## Korenix JetNet Industrial Managed Switch JetNet 4510 SOFTWARE RELEASE Notes

### About This Software Version

Firmware Version	Boot Loader Version	Release Date	Model
V2.0	V1.6.2.10	Jan. 9, 2008	Official release for JetNet 4510
V2.1	V1.6.2.10	21, Apr, 2008	Official release for JetNet 4510

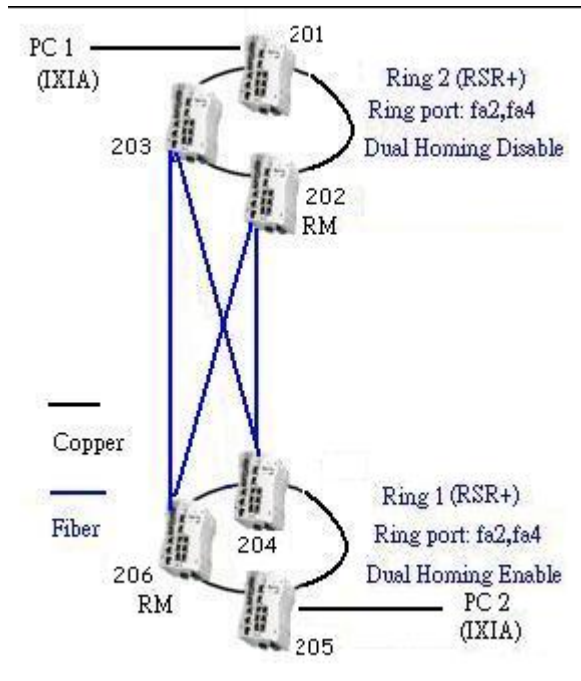
- Rename Rapid Super Ring to Multiple Super Ring with various features as following diagram.

- Implement new ring algorithm, the restore time of Rapid Super Ring (R.S.R.) and Rapid Dual Homing (R.D.H.) reduced to zero second.
